**Wilsonville City Hall
Development Review Board Panel A**

**Memorial Park Community Garden & Dog Run Parking Area: AKS
Engineering and Forestry - Representative for City of Wilsonville -**

Case File: DB17-0028 Class III Site Design Review

Exhibit A1
Staff Report
Wilsonville Planning Division
Memorial Park Community Garden & Off-Leash Dog Area Parking Improvements

Proposed Parking Area

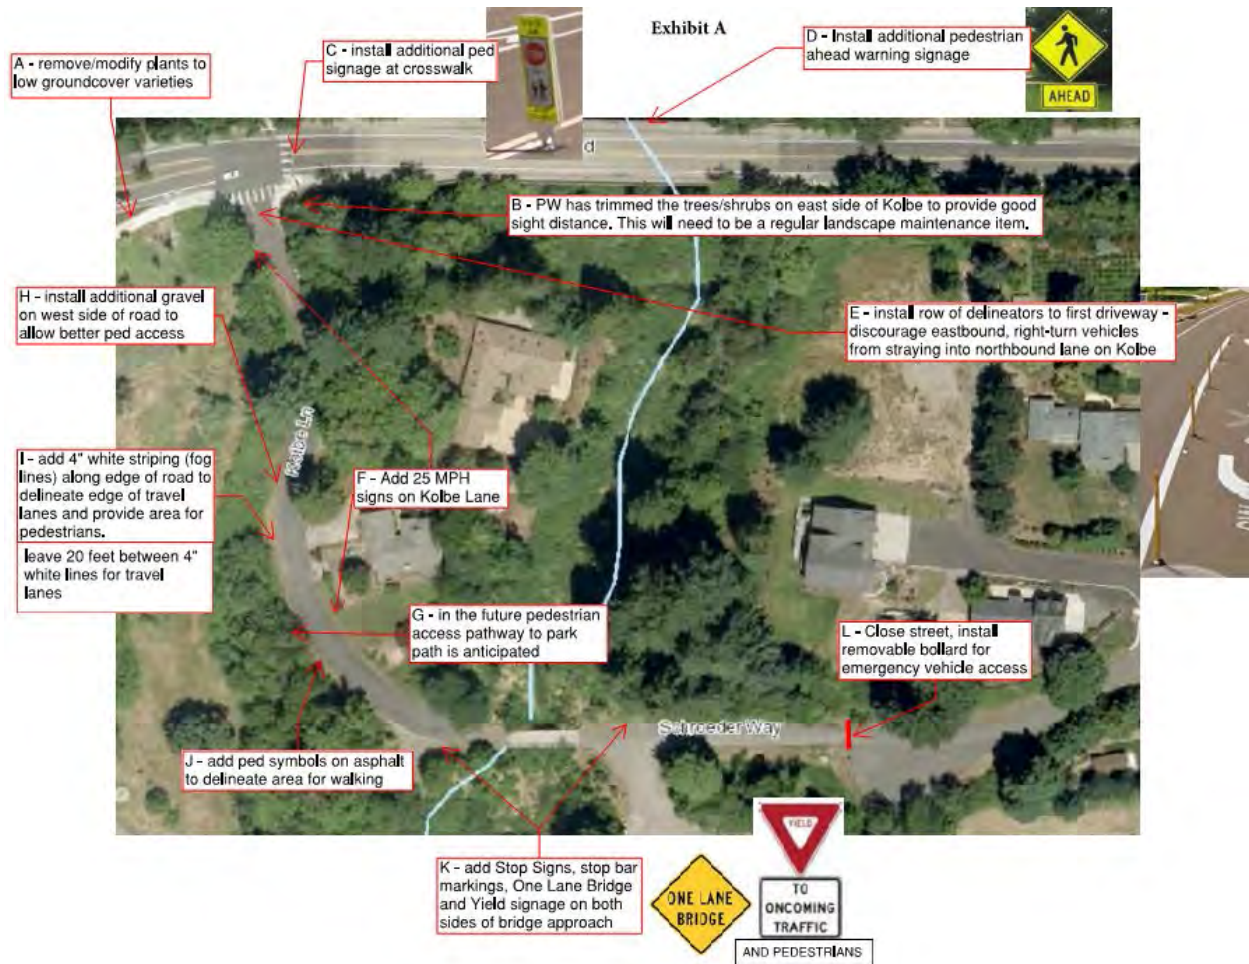
As part of the effort to implement Phase One of the Memorial Park Master Plan area the City proposes adding a 33-lot paved parking area adjacent to the existing community garden. The parking area will serve the community garden as well as a planned off-leash dog area.

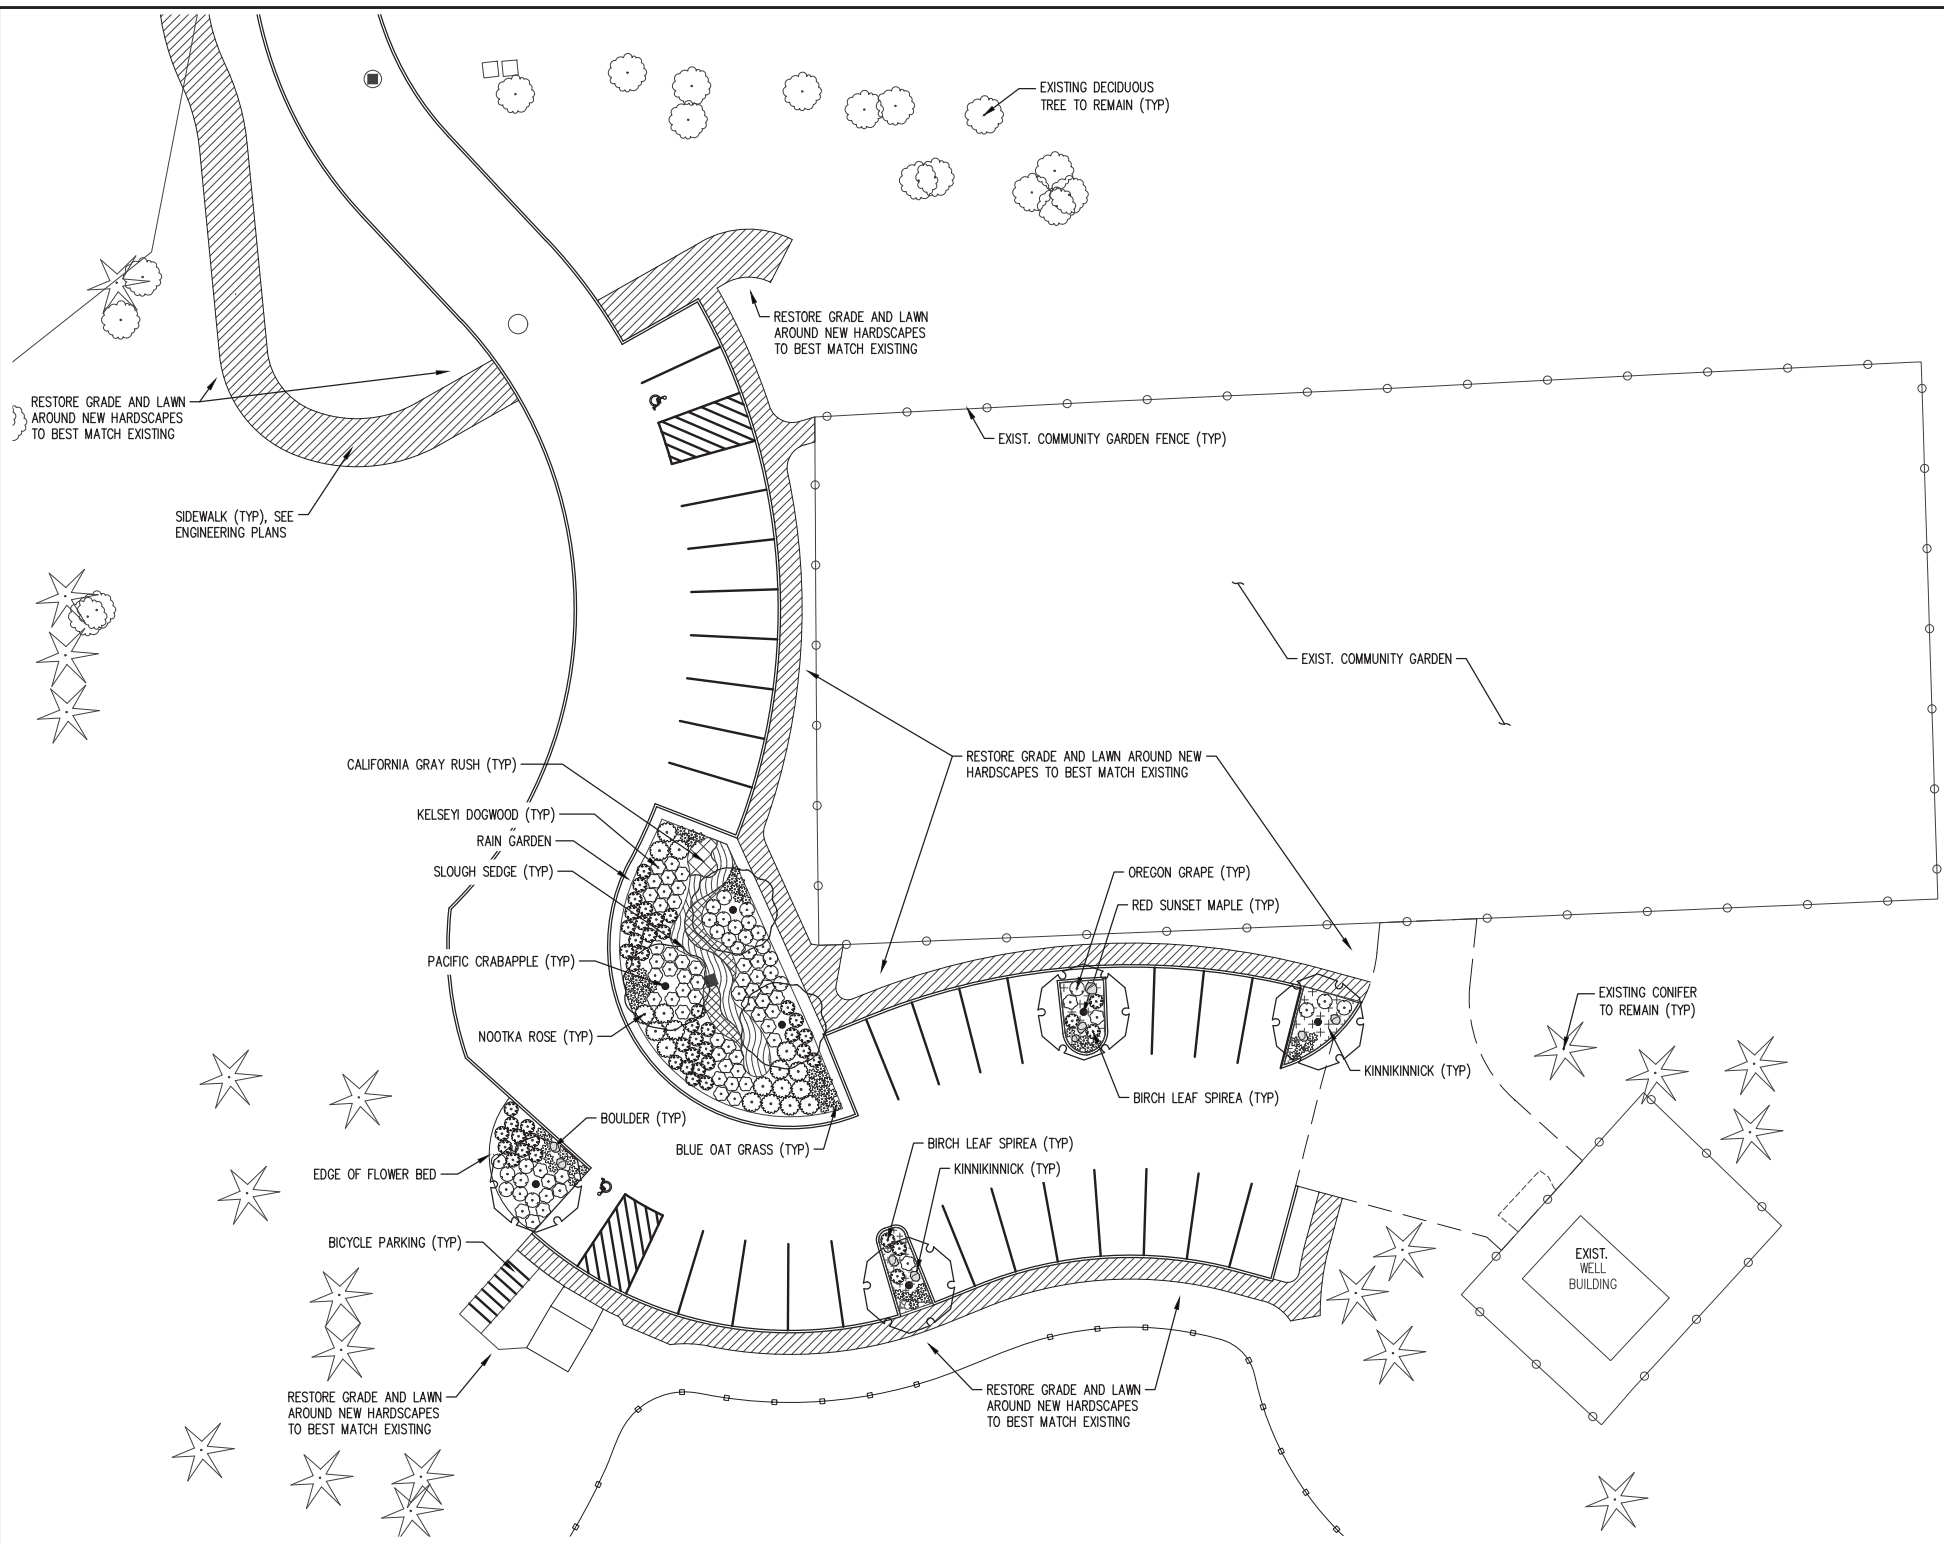
50. Condition of Approval PD 5 requires meeting the detailed requirements of this subsection. Of particular note, Sheet P1-07 of the applicant's plan set, shows 1-gallon containers. The Condition of Approval requires 2-gallon containers.

51. As stated on Sheet P1-07 of the applicant's plan set, Exhibit B2, the plant material requirements for trees will be met as follows:
- Trees are B&B (Balled and Burlapped)
 - Tree are 2" caliper.

52. The applicant's landscape plan (Sheet P1-07) provides sufficient information showing the proposed landscape design meets the standards of this subsection related to use of native vegetation and prohibited plant materials.

54. Applicant's Sheet P1-07 in Exhibit B2 show all existing and proposed landscape areas. The to-scale plans show the type, installation size, number and placement of materials. Plans include a plant material list. Plants identification is by both their scientific and common names.

77. The landscape plan, sheet P1-07, shows all tree planting areas at least 8 feet wide and 8 feet deep.

78. With 33 spaces, the stated ratio of 1 tree for every 8 spaces or fraction thereof requires 5 additional trees. The landscape plan, sheet P1-07, shows 4 trees in planting areas spread throughout the parking area and 3 trees in the larger storm planter, exceeding the requirement of 5 trees.
